SUBMITTAL OF DANGEROUS WASTE PERMIT PACKAGE PTF-009, REVISION 2, FOR THE PRETREATMENT FACILITY

Permit Package PTF-009, Revision 2, Supplemental
Permit Package for FRP-VSL-00002A, FRP-VSL-00002B,
FRP-VSL-00002C, and FRP-VSL-00002D Vessel Alterations

Supplemental Permit Package PTF-009, Rev. 2 Description
Vessel Alterations to FRP-VSL-00002A/B/C/D

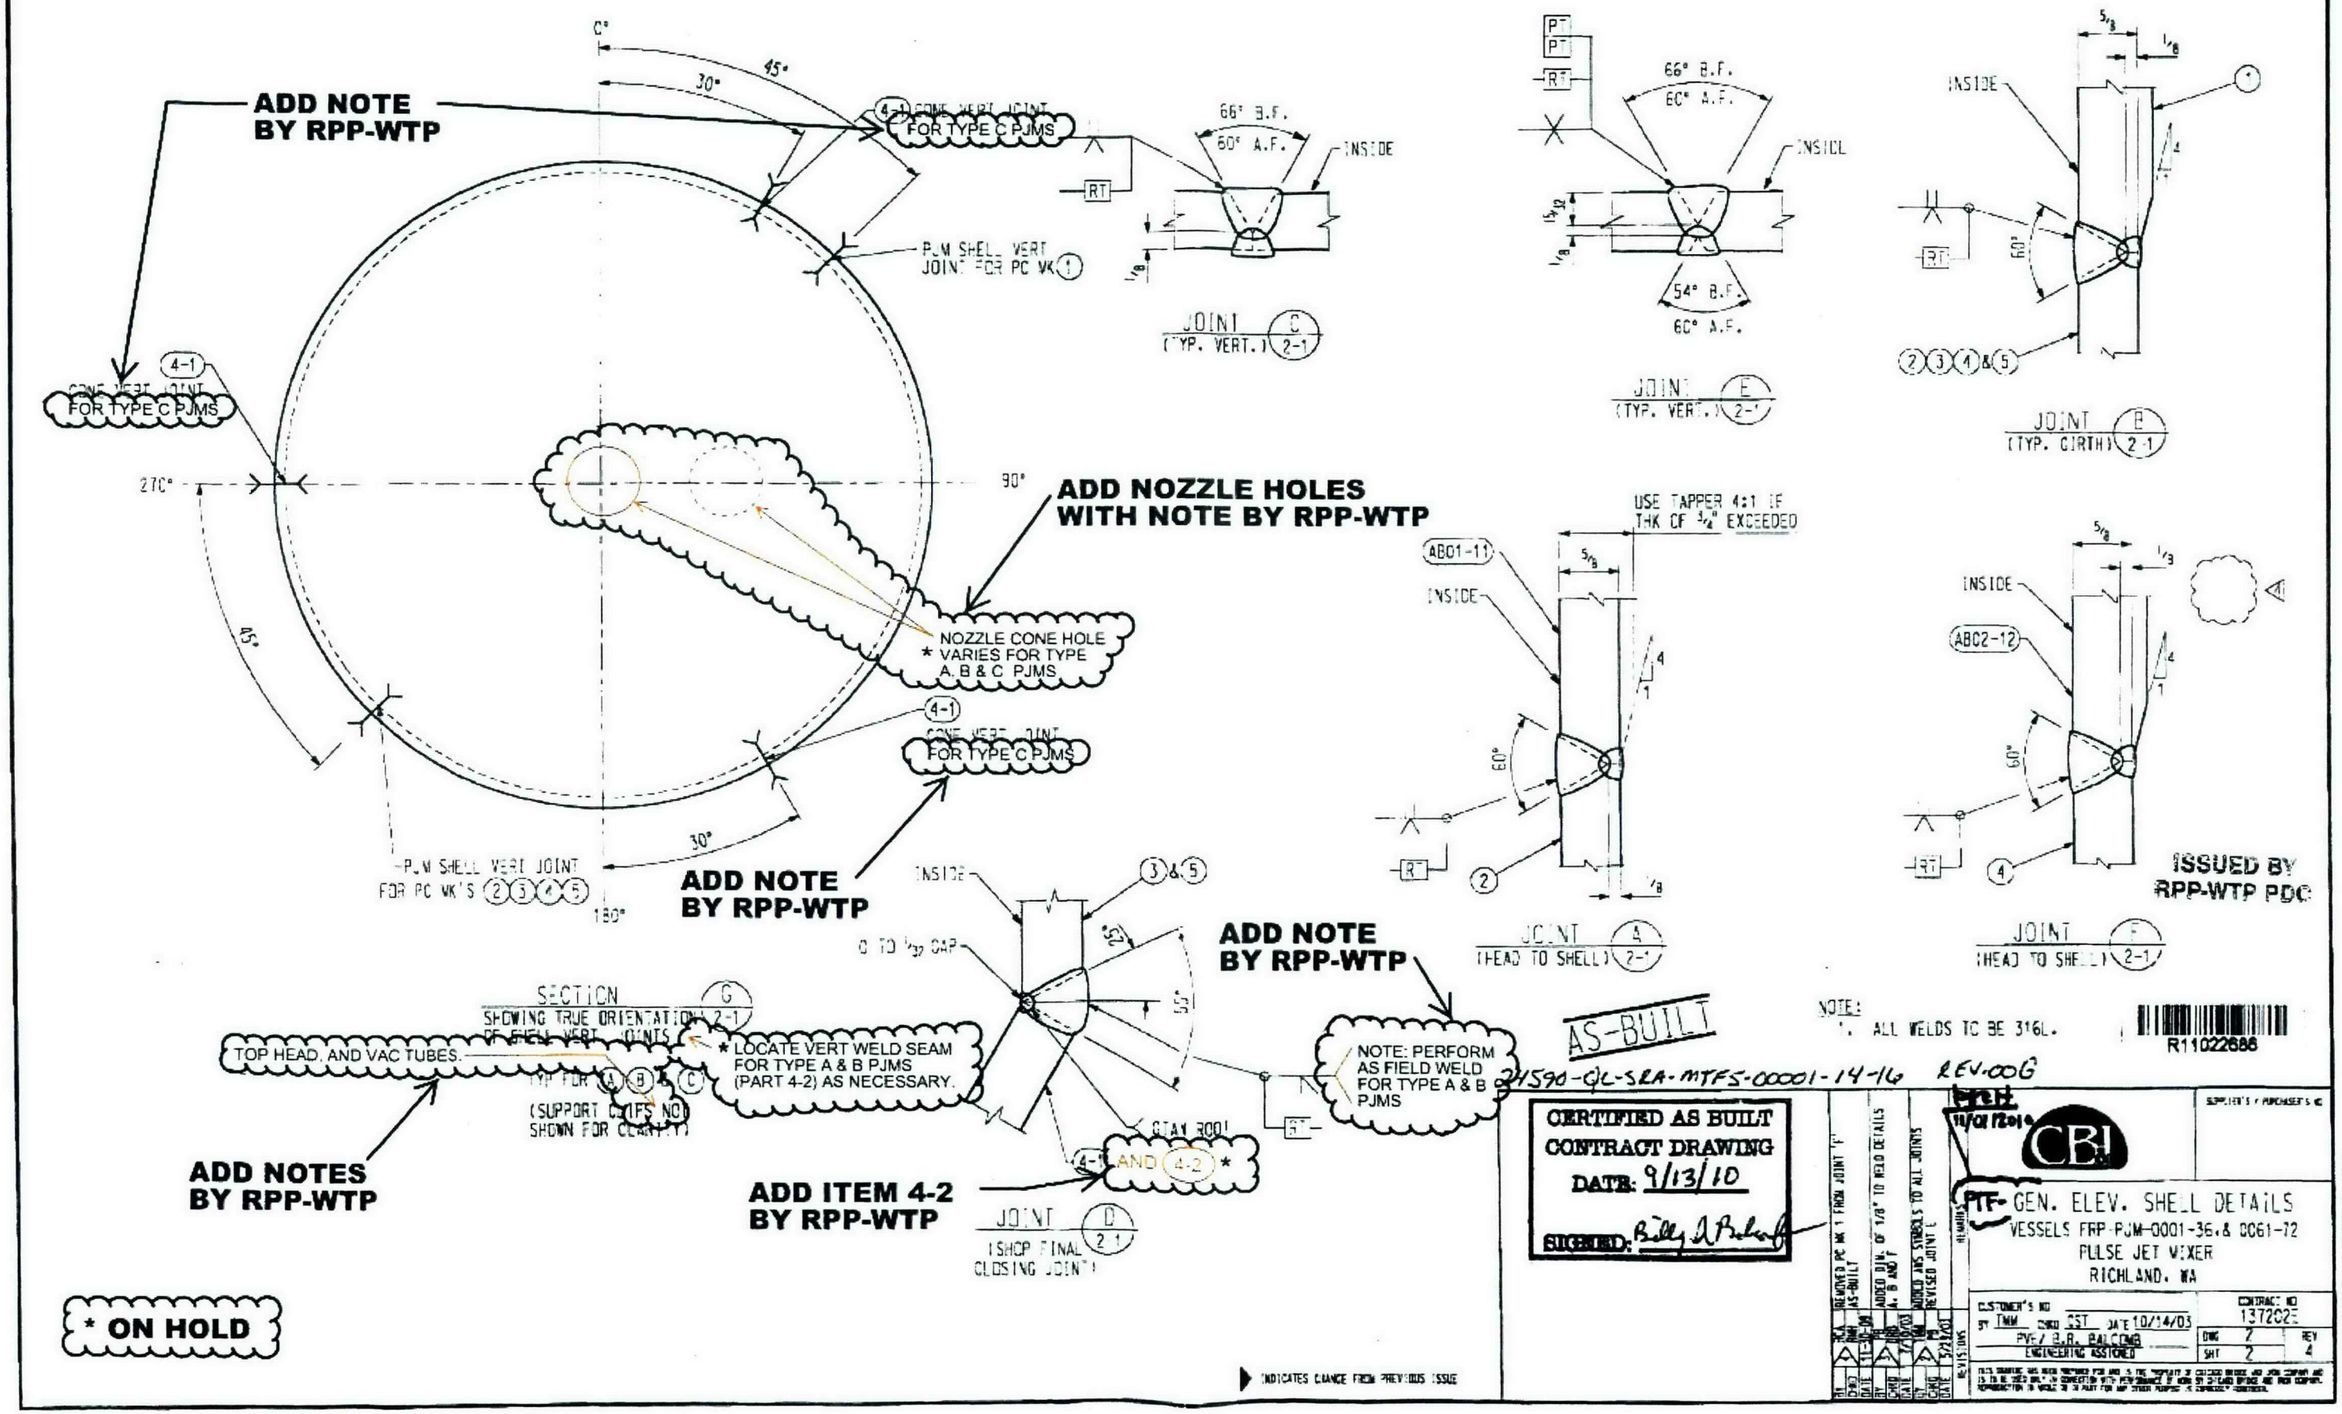
MOVE SECTION G-G DOWN BY RPP-WTP

ADD NOTE BY RPP-WTP
FOR TYPE C PJMS
PJM SHELL VERT JOINT FOR PC WK 1
JOINT C (TYP. VERT.) 2-1
66° B.F.
60° A.F.
INSIDE
RT
PT
54° B.F.
JOINT E (TYP. VERT.) 2-1
JOINT B (TYP. GIRTH) 2-1
2 3 4 & 5
ADD NOZZLE HOLES WITH NOTE BY RPP-WTP
NOZZLE CONE HOLE

* VARIES FOR TYPE A, B & C PJMS
PJM SHELL VERT JOINT FOR PC WK'S 2 3 4 5
ADD NOTE BY RPP-WTP
USE TAPPER 4:1 IF THK OF 3/4" EXCEEDED
ABO1-11
JOINT A (HEAD TO SHELL) 2-1
ABO2-12
JOINT F (HEAD TO SHELL) 2-1
ISSUED BY RPP-WTP PDC
SECTION G SHOWING TRUE ORIENTATION OF EVEN VERT JOINTS 2-1
TOP HEAD, AND VAC TUBES.
TYP FOR A B & C
(SUPPORT CLIPS NOT SHOWN FOR CLARITY)

ELEVATION
ASSEMBLY A & B

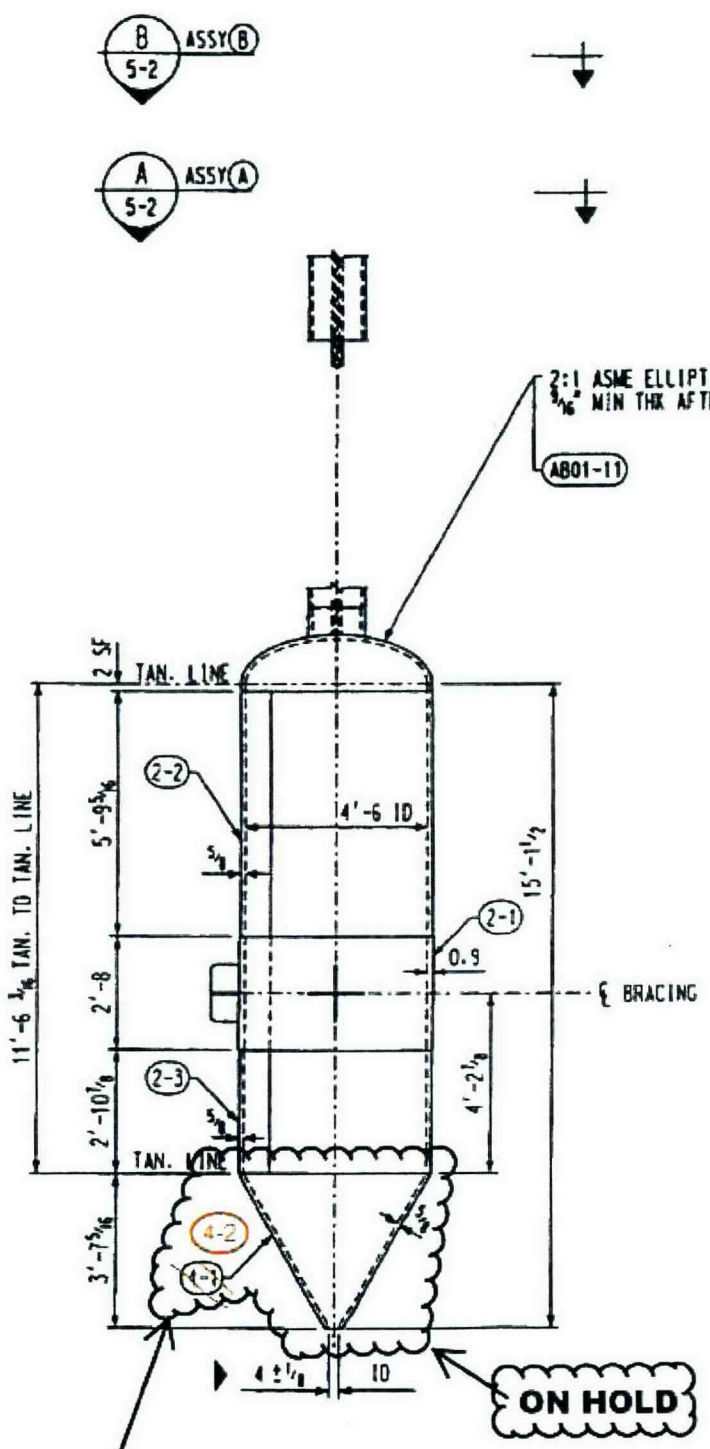
DELETE ITEM 4-1 AND REPLACE WITH ITEM 4-2 BY RPP-WTP

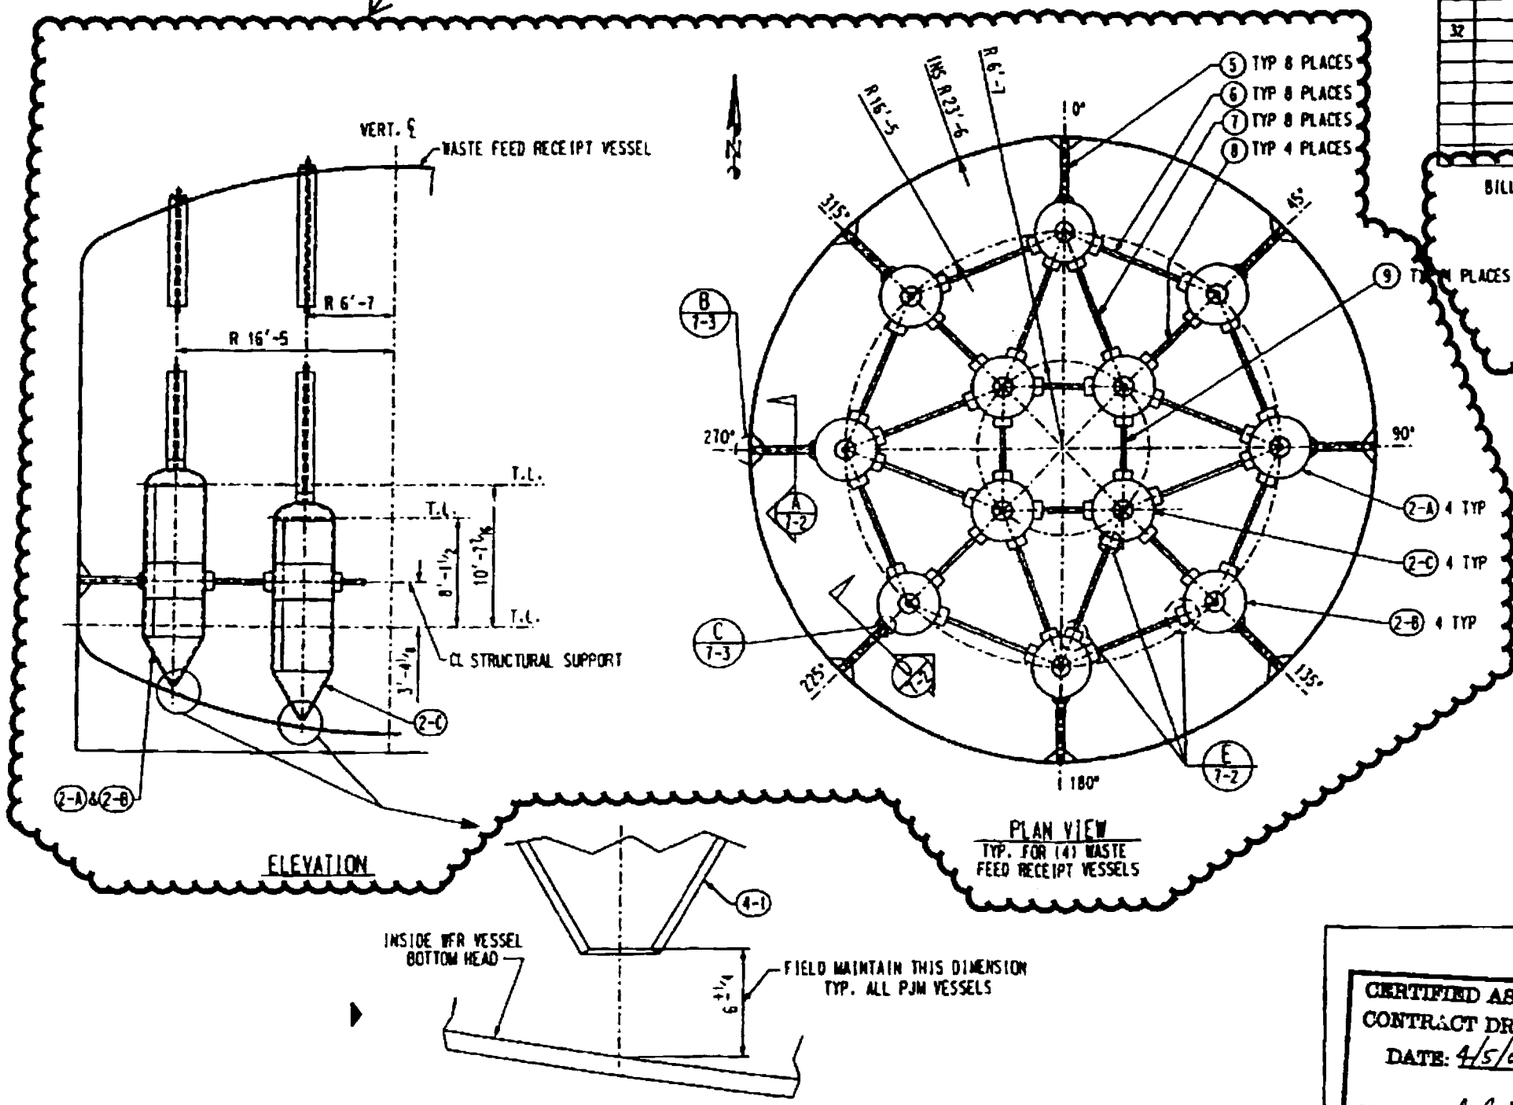
ADD ITEMS 7-10 THRU 7-30 TO BILL OF MATERIAL LIST BY RPP-WTP

ELEVATION

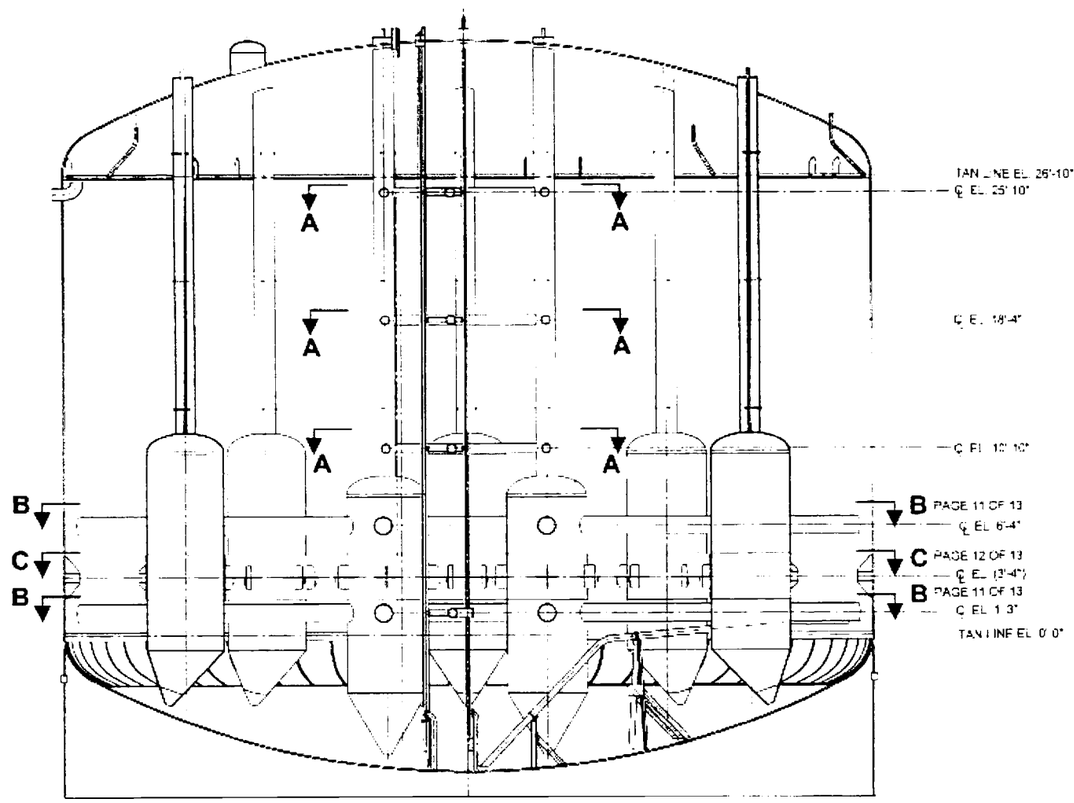
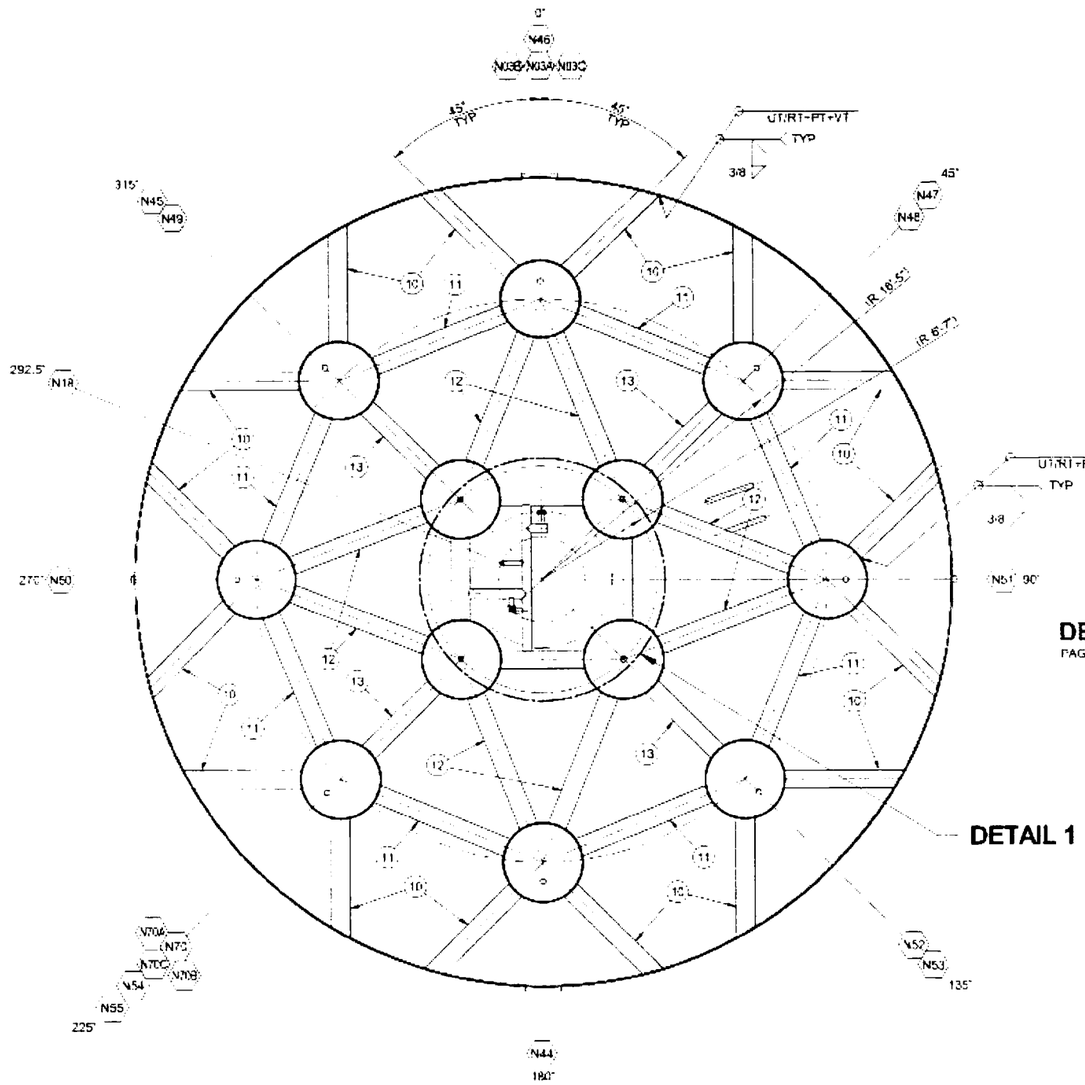
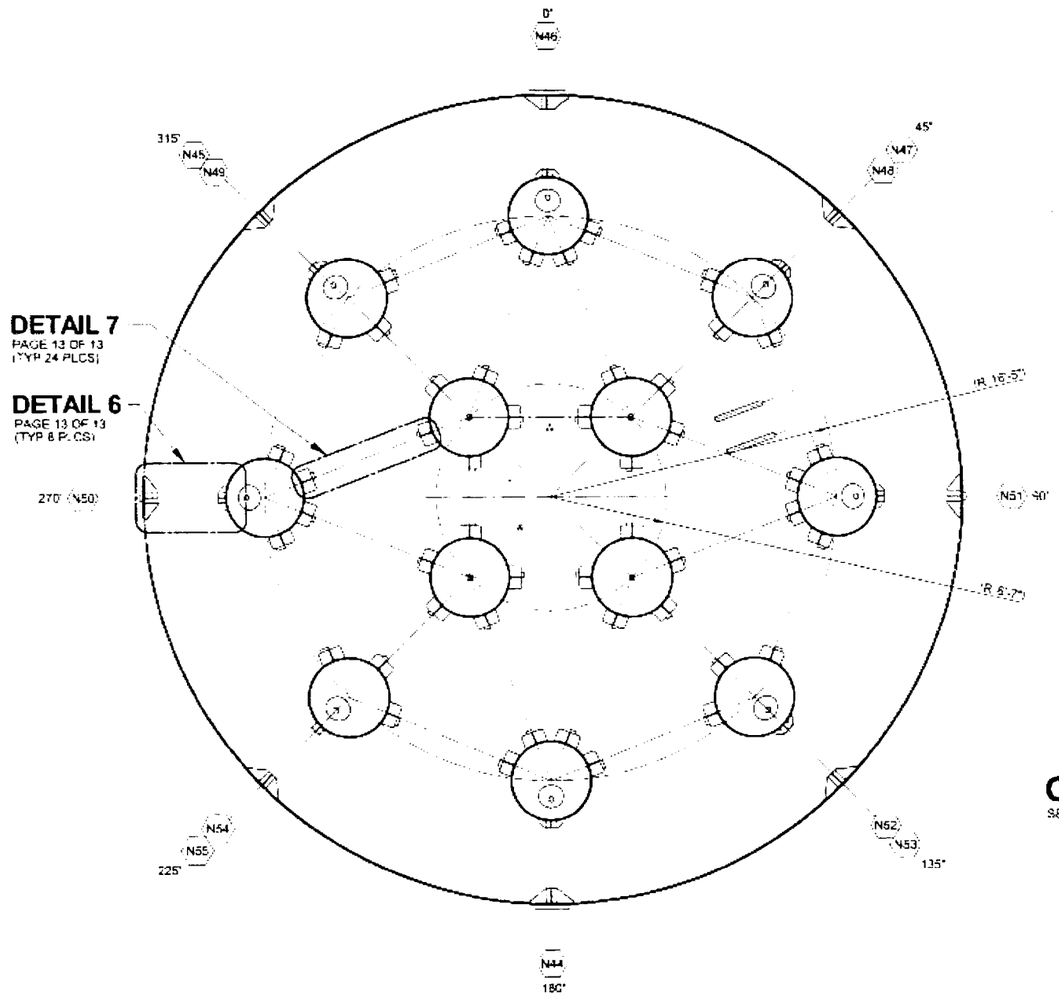
a) Elevation and Plan View: Delete Elevation and Plan View and replace with Elevation and Sections A-A, B-B and C-C and Detail 1 shown on Attachment 1, pages 10, 11 and 12 of this VDCN.

HOLD NOTE:
FINAL INSTALLATION OF PJM NOZZLE CONES TO PJM SHELL IS ON HOLD PENDING FINAL DESIGN RELEASE FROM BNI

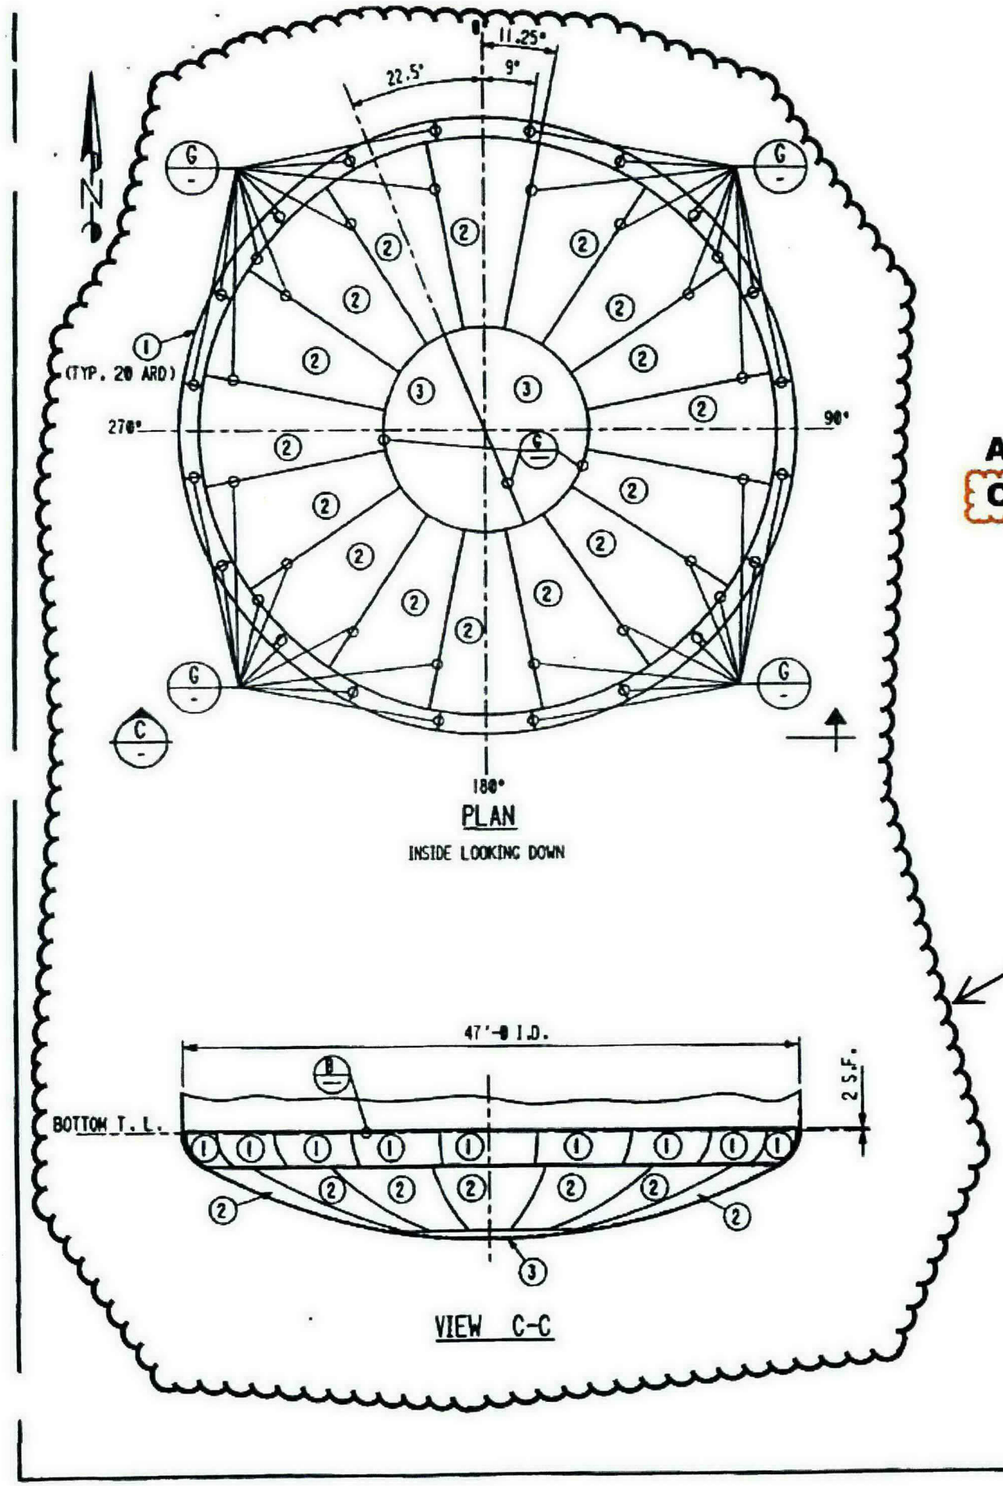
ADD ITEM 5-4 BY RPP-WTP
